RP7 - NIE Networks Price Control 2025-2031

Final Determination Annex P
Assessment of Network Investment Direct
Allowances
30 October 2024

This annex sets out the Utility Regulator's assessment of NIE Networks' proposals for direct network investment, which forms part of the overall capital investment proposed by the company for the RP7 price control period.

Figure 3.1: Outturn cumulative and annual average unit cost from 2013 to 2023

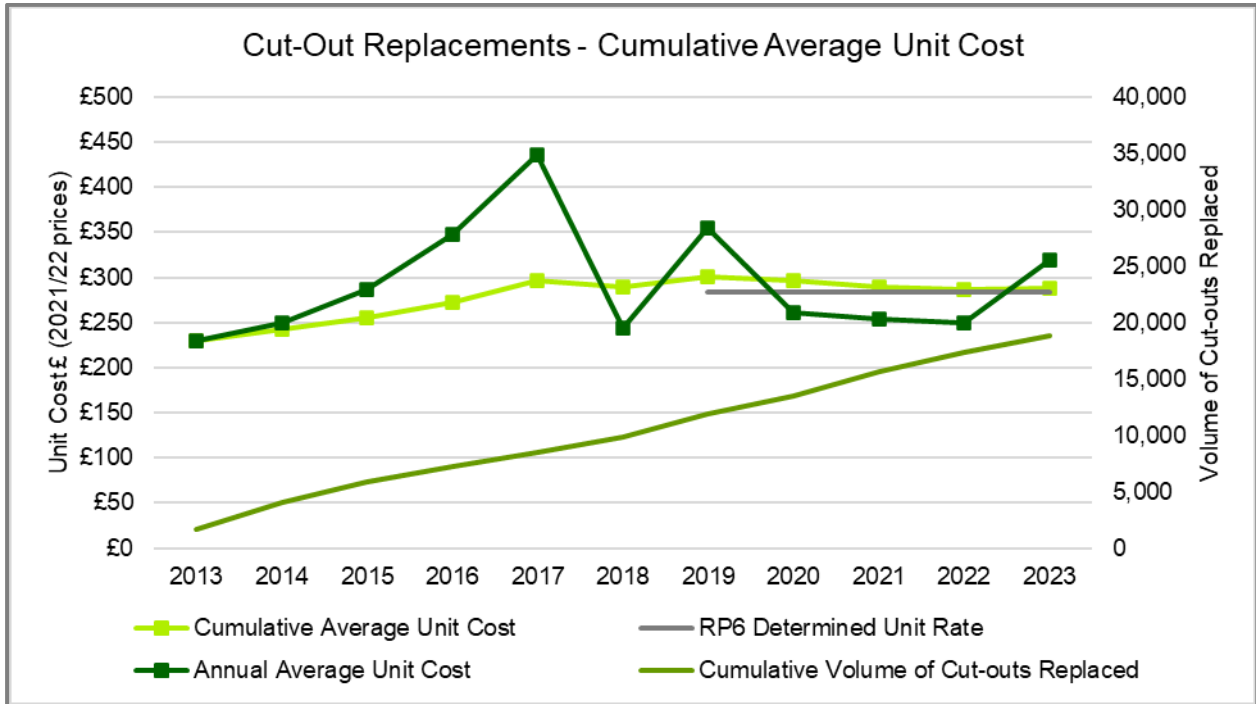
3.128 For RP6 we set the allowed unit rate at £282.73, which was the RP5 outturn to that stage. NIE Networks argued then that it had undertaken a 98:2 simple versus complex split in RP5 and that determining based on the RP5 outturn wasn't suitable for its forecast 90:10 split in RP6. The RP6 outturn to March 2023 is £288.42, 1.7% above the determined allowance. We believe this indicates our RP6 approach was appropriate and should be maintained going forward. We have therefore set our draft determination unit cost at the RP6 outturn to March 2023.

Figure 3.2: Outturn and forecast delivery volumes

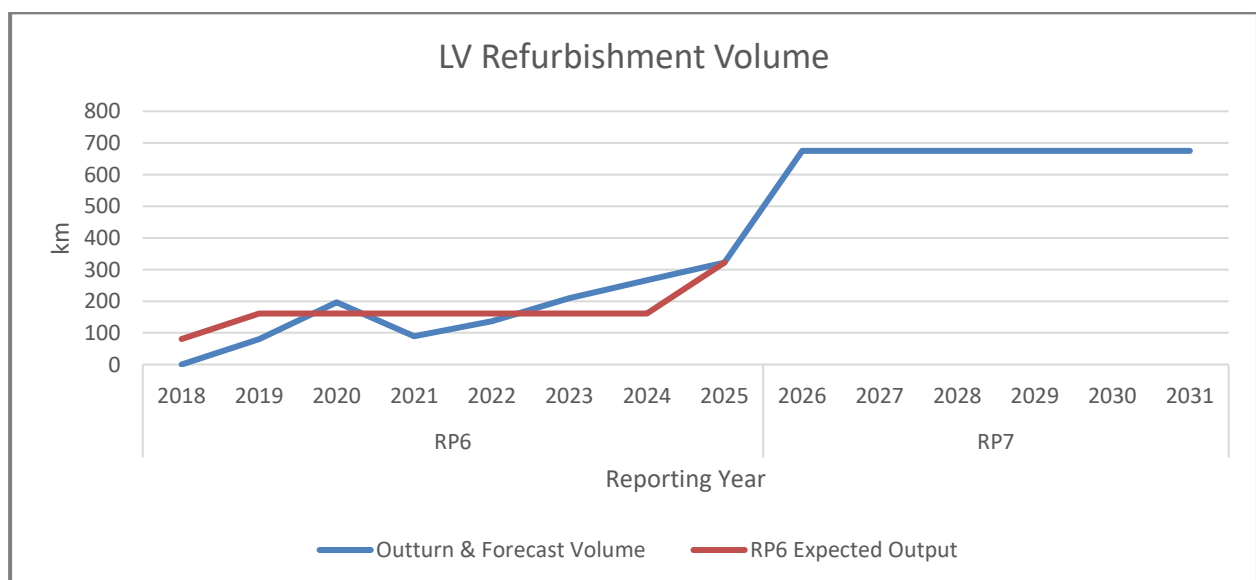
3.197 NIE Networks has proposed an ambitious plan to increase delivery of LV overhead line refurbishment volume during RP7. The graph shown in Figure 3.2 shows output (outturn and forecast) during RP6 and the subsequent increase during RP7.

3.199 Based on historic outturn volumes being below those expected, we have concerns that NIE Networks will be unable to increase output to its proposed RP7 volumes. However, given the upturn in output since 2021 we are willing to allow the RP7 proposed volumes (less the deduction detailed in Paragraph 3.196) in the knowledge that the deferral mechanism will deal with any under-delivery in RP7.

Figure 3.3: Outturn unit cost

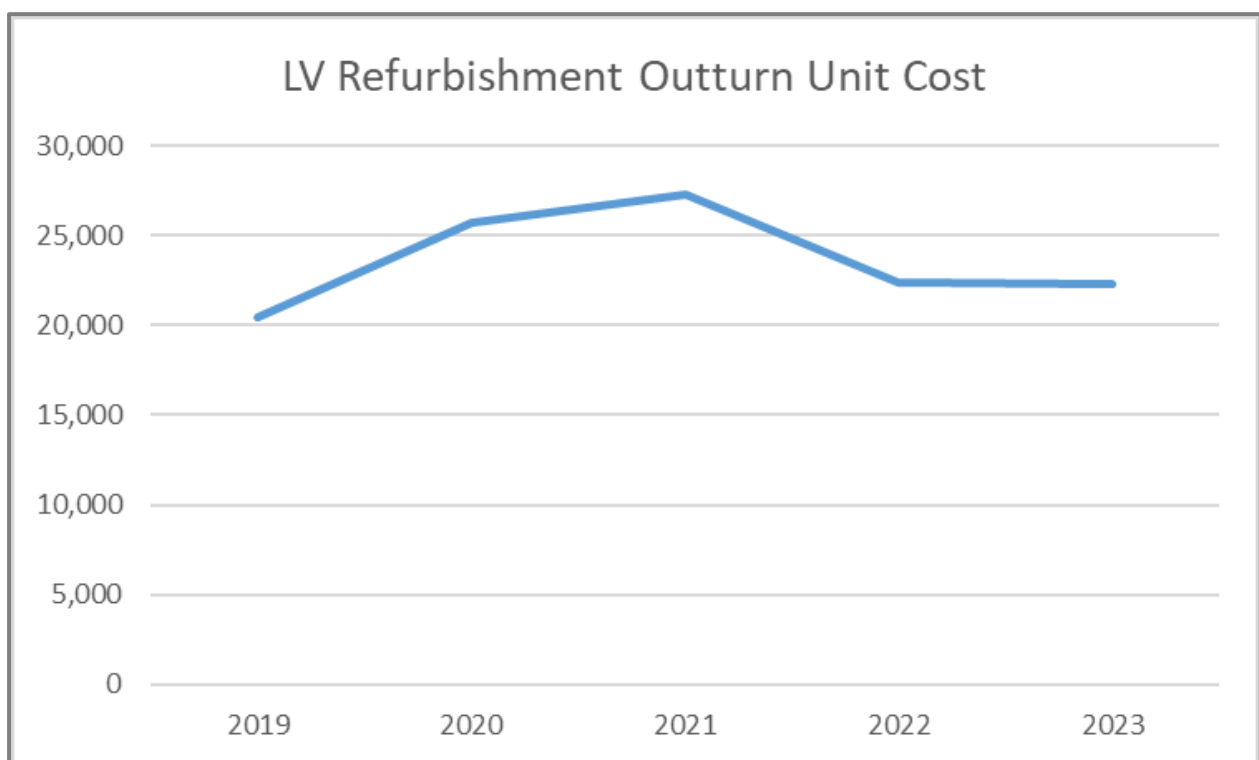
3.200 The historic outturn unit cost/km is shown in Figure 3.3.

3.201 We are aware of increased contractor costs negotiated by NIE Networks in the second half of 2022. However, due to reporting lag we have seen no evidence of the increased costs yet.

Figure 3.4: D43d outturn and forecast data

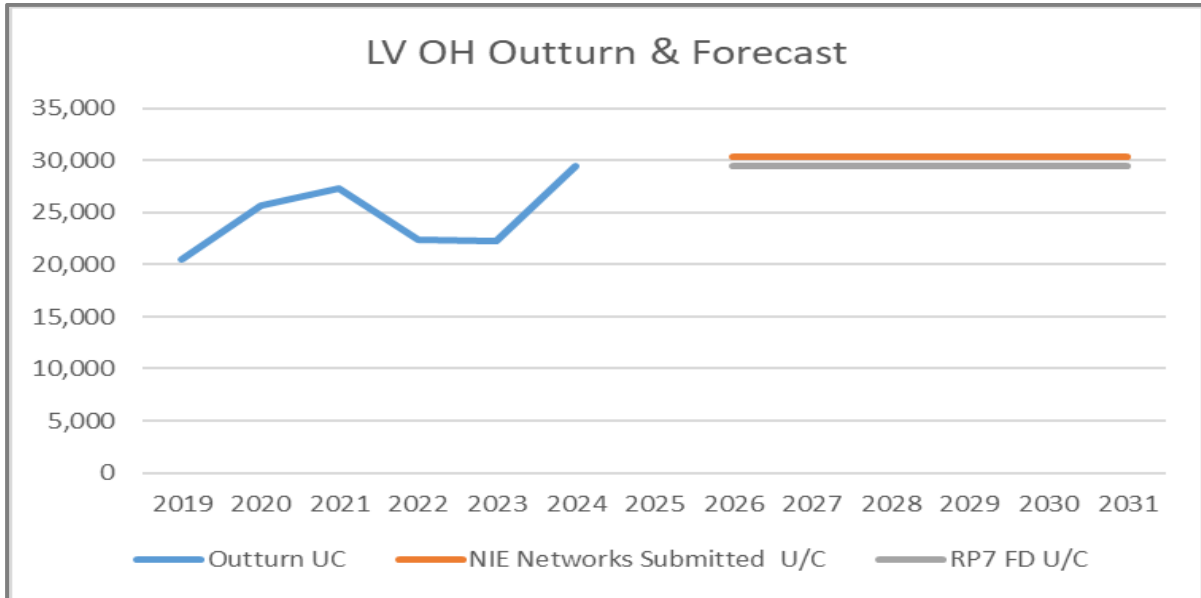
- 3.220 In its response to our draft determination, NIE Networks stated that we had not taken full account of its contractor cost increases. We were aware of the cost increases prior to the publication of the draft determination, and we made a commitment to review the data prior to publication of this final determination.
- 3.221 The RIGs data submitted by the company in July 2024 (Figure 3.4 below) indicated an upturn in costs for 2023/24 delivery but not to the extent requested by the company in its business plan submission. Therefore, we will use the last year of data to determine our RP7 allowances.
